Pend Oreille River Temperature Total Maximum Daily Load

Water Quality Improvement Report

November 2011 *Revised*
Publication No. 10-10-065

Figure 5. Study period daily average discharge levels in relation to 1953-2008 discharge percentiles . USGS station 12396500, Pend Oreille River below Box Canyon near Lone, WA.

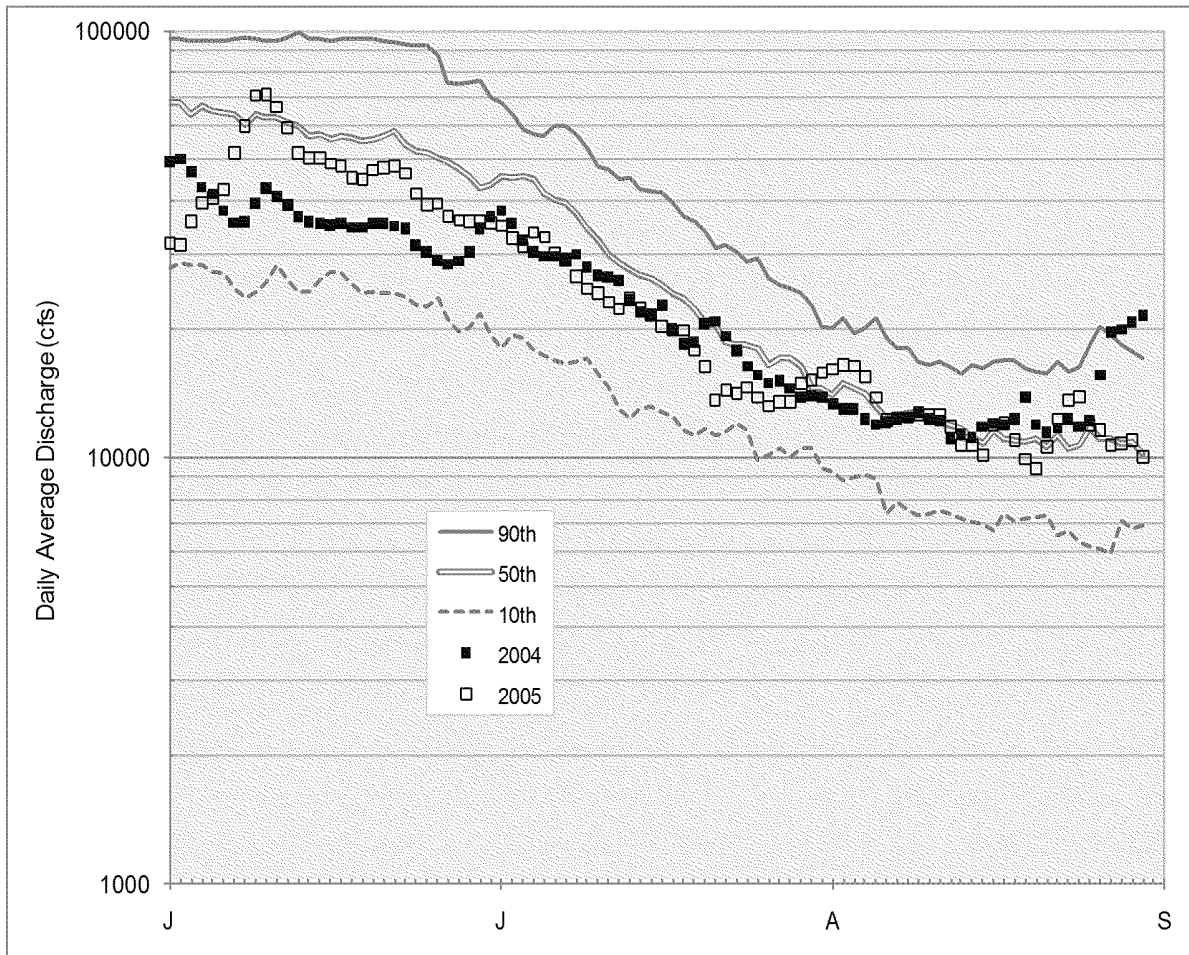
17. P. 21, Figure 5: There is a discrepancy between the legend and the line in the graph for 50th percentile flow.
